Service Bulletin

Bulletin No.: PI0686F

Subject: Front Seat Lateral Movement, Clunk, Squeak, Click Noise or Shift While Cornering

Models: 2012-2016 Buick Regal

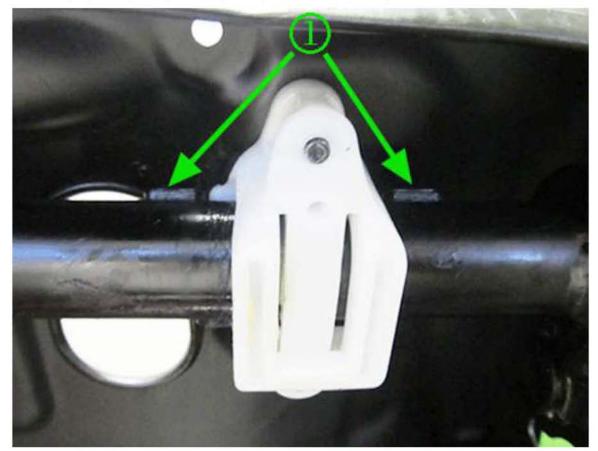
Important: On some vehicle models, a production change added welded brackets (1) to the seat crossbar on each side of the guide block to help retain its position. On these particular vehicles, it will be necessary to rework the new clip service part to ensure proper installation to the crossbar.

Note: Cruze shown, all others similar.

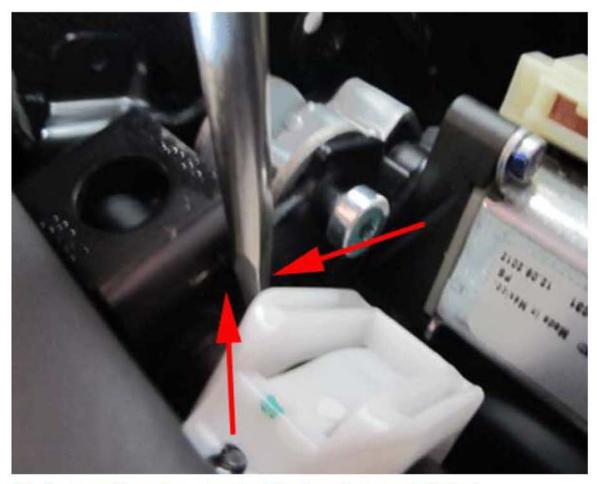
- 2. Locate the front crossbar as shown (1).
  - Identify the inboard guide block (2) on manually adjusted seats (closest to center console).
  - Identify the outboard guide block (2) on power adjusted seats (closest to door).
  - Inspect the seat crossbar for the existence of the welded brackets noted in the Important above.
    - If no brackets are found on the crossbar, continue ahead to step #3.

If brackets are evident, it will be necessary to remove plastic material from the top side of the guide end of the clip to enable installation.
Using a grinder, or similar tool, remove approximately 10 mm (0.40 in) of material (1) from the top, down to the mold seam line (2).

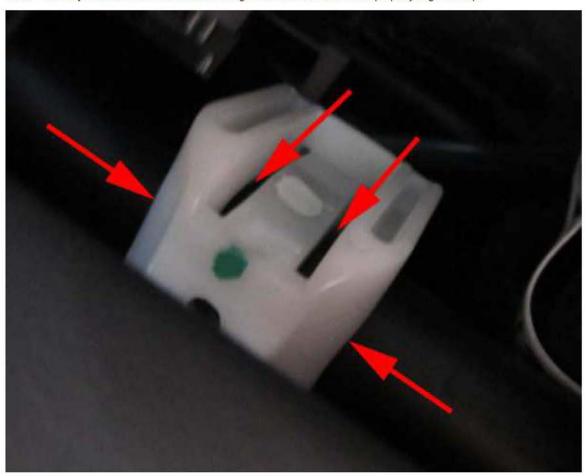
3. Install the clip as shown. Ensure the clip is fully seated around the crossbar and on the guide block.

Note: You may need to move the crossbar using a flat head screwdriver to properly align the clip.

**Note:** Spray Super Lube, P/N 12346241 (in Canada, P/N 10953474), or equivalent to the areas on the white clip, as shown in the illustration above, to ensure that the noise is eliminated.

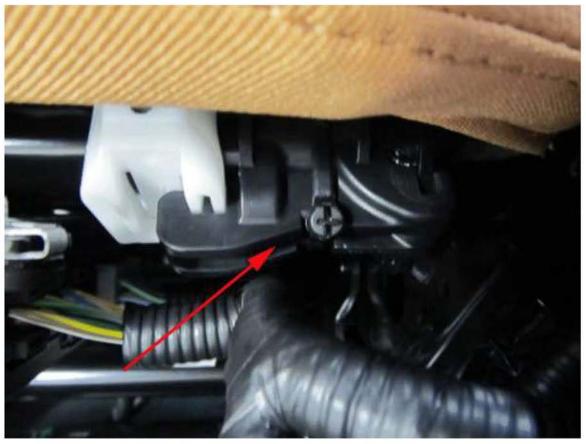
4. Install a nylon wire tie as shown. Trim the excess wire tie material.
